Section 92 Response Attachments

Attachment 6 - Traffic

11117-4
12 December 2012

**Watercare Central Interceptor
Transport Response to Section 92 Request for Further Information**

Access to Secondary Site

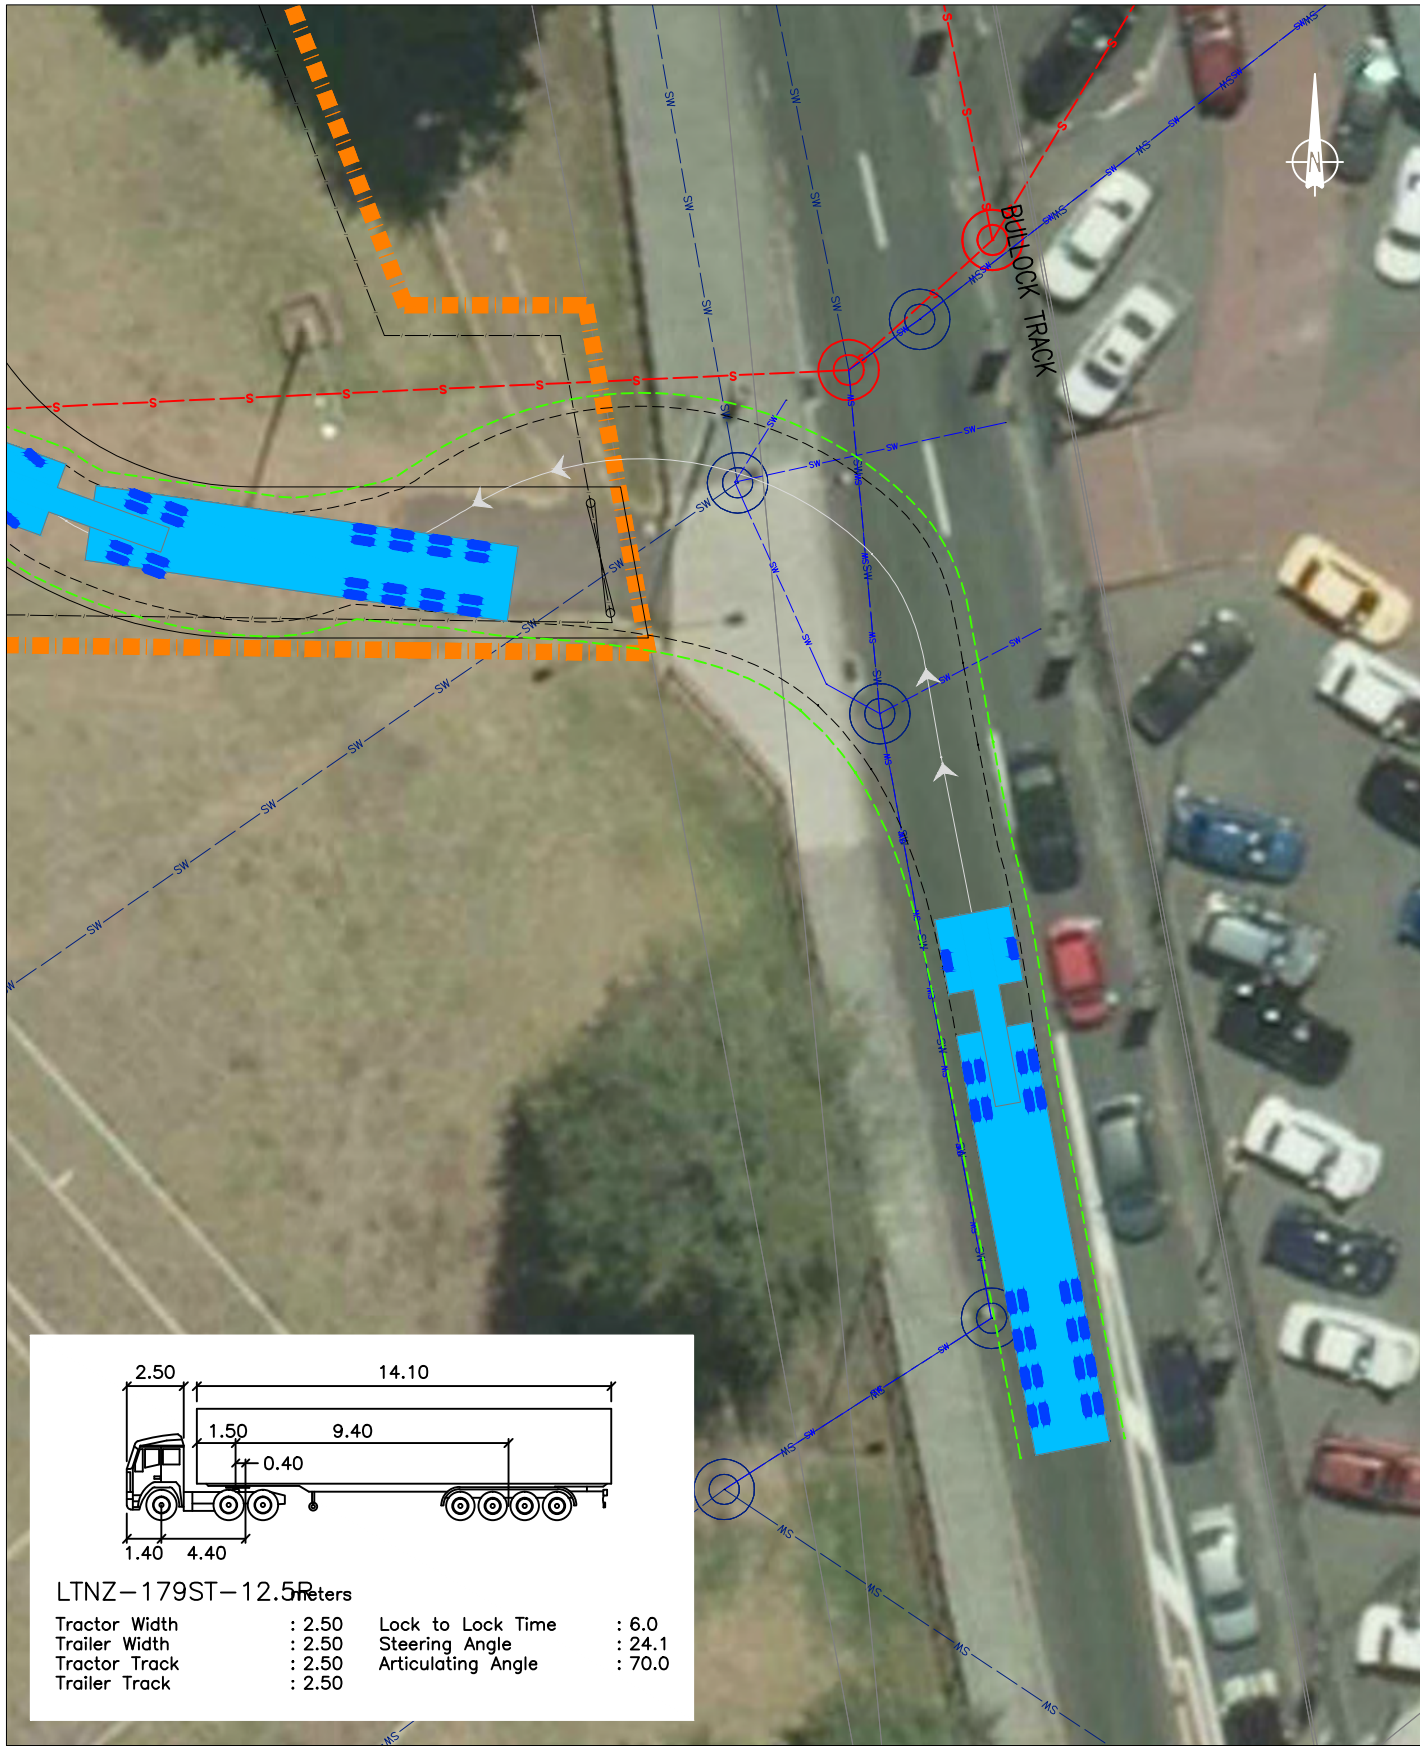
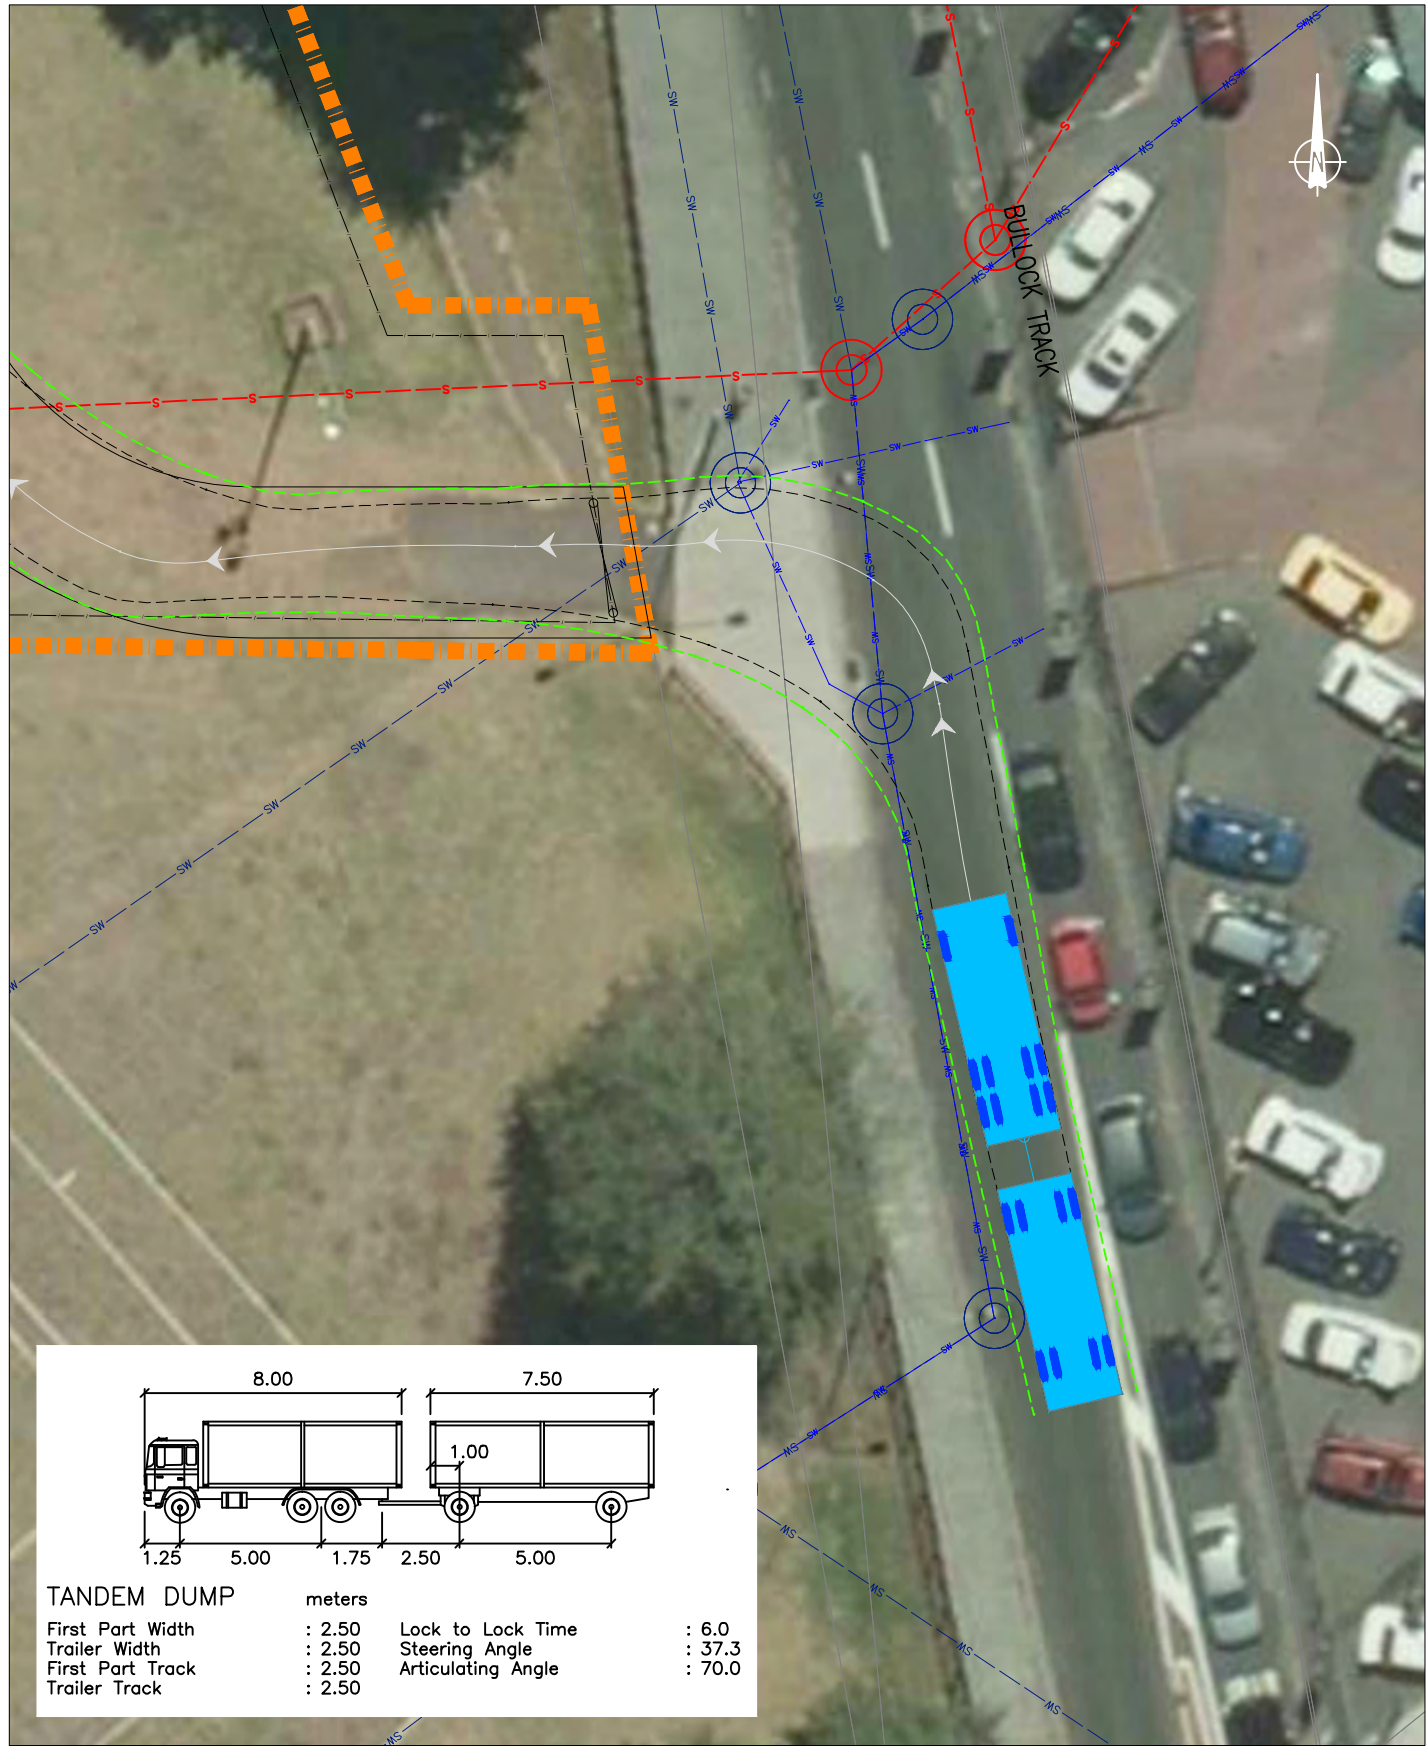
- *The secondary site on the eastern side of the Caltex service station on Great North Road is constrained by existing structures/facilities and topography. We would therefore like to see if it is feasible to turn a truck around on site using the existing access gate. A truck backing from or onto Great North Road would create potential significant safety concerns. Could a tracking assessment be supplied?*

The secondary site area includes the grassed space between the Caltex service station and the SH16 off-ramp. Truck tracking curves shown in Figure 2a of Appendix A demonstrate the turnaround of a truck on-site using a proposed access on the western side of the site off Great North Road. The proposed layout provides greater separation of the SH16 off-ramp than the existing access gate and is considered a better and safer location than current access. Given the confined area of this site, the entire site including the grassed area will be used by trucks for manoeuvring and the manoeuvring path will be adjusted in accordance to the works to ensure no reverse manoeuvring onto the road is required.

Watercare Central Interceptor
Western Springs (WS1) - Truck Tracking

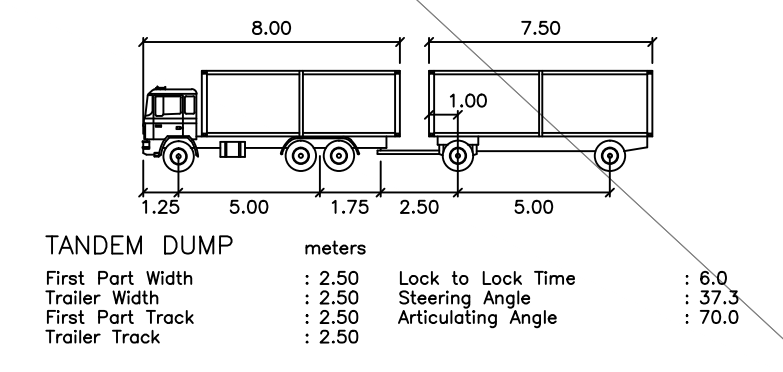
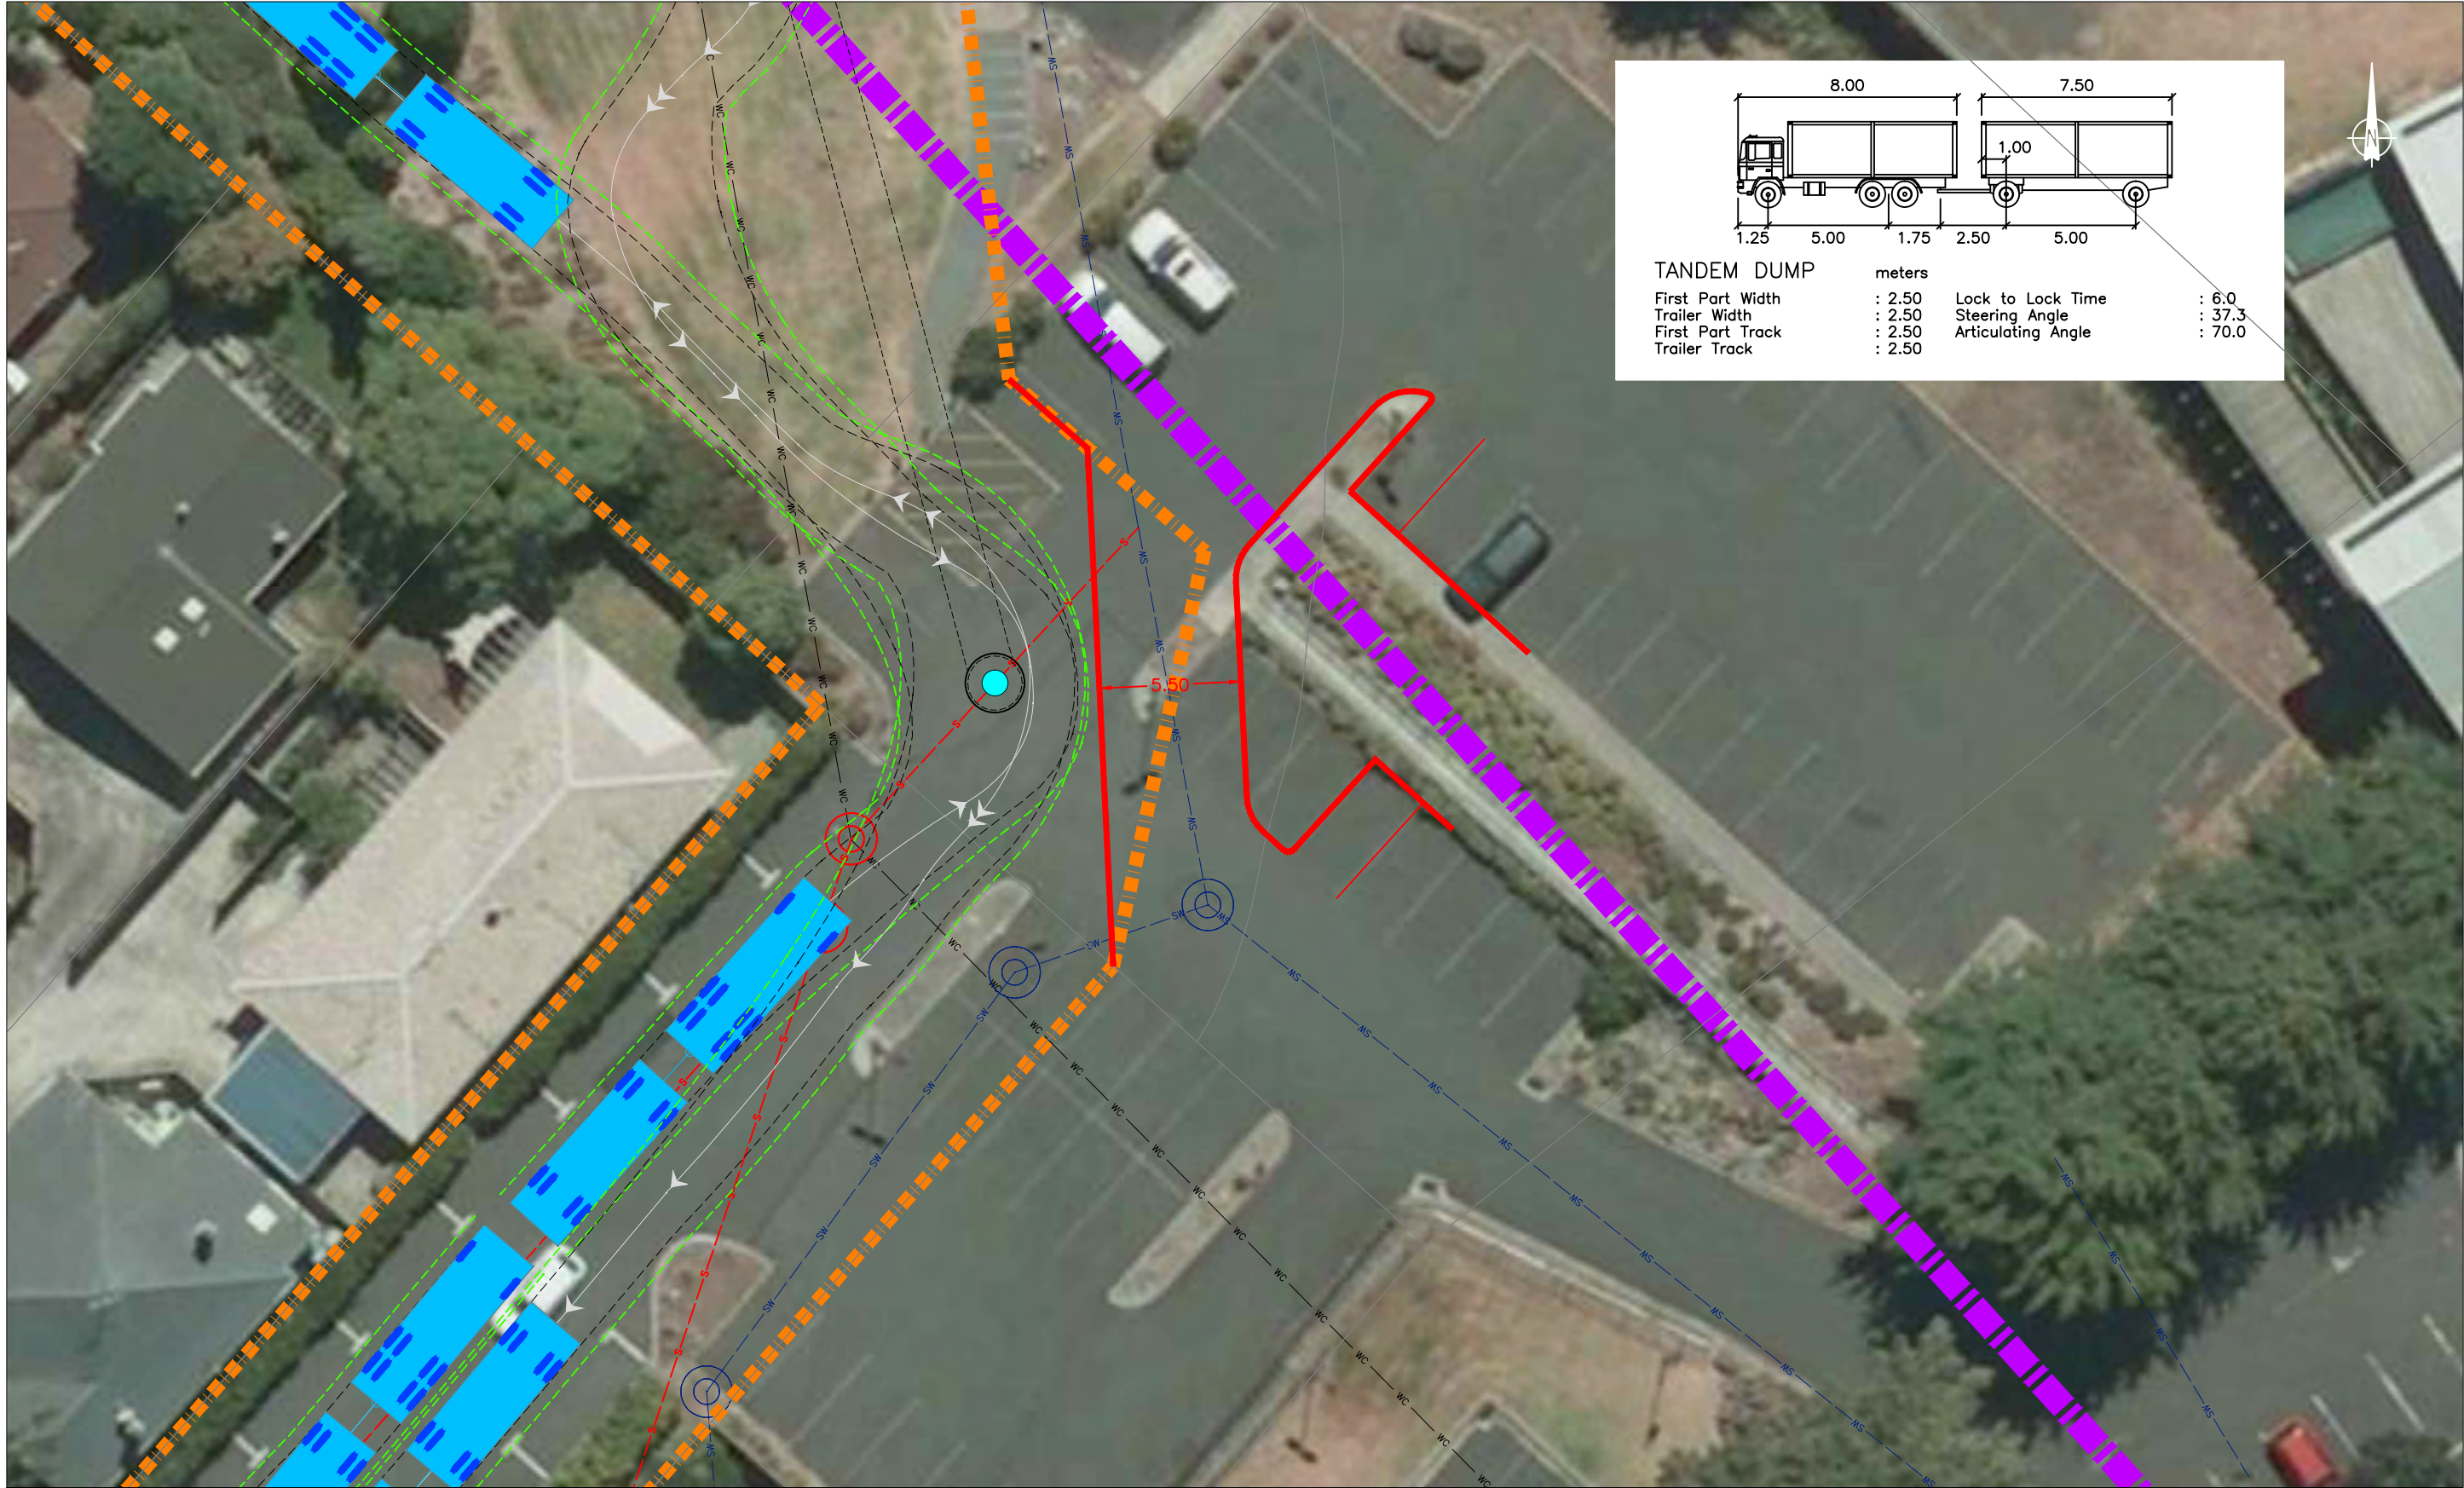
- *Figure 2 from the Traffic Impact Assessment report shows the tracking curve for a semi-trailer truck extending outside the designated works area at the Bullock Track entrance. Confirm if widening of the existing crossing is required.*

Widening of the Bullock Track entrance will be required as per the tracking curves shown on Figure 2 of the TIA report. This is shown in a close-up revised version Figure 2b, which shows the tracking curve remaining within the designation but widens the driveway to the north by approximately 2.5m.
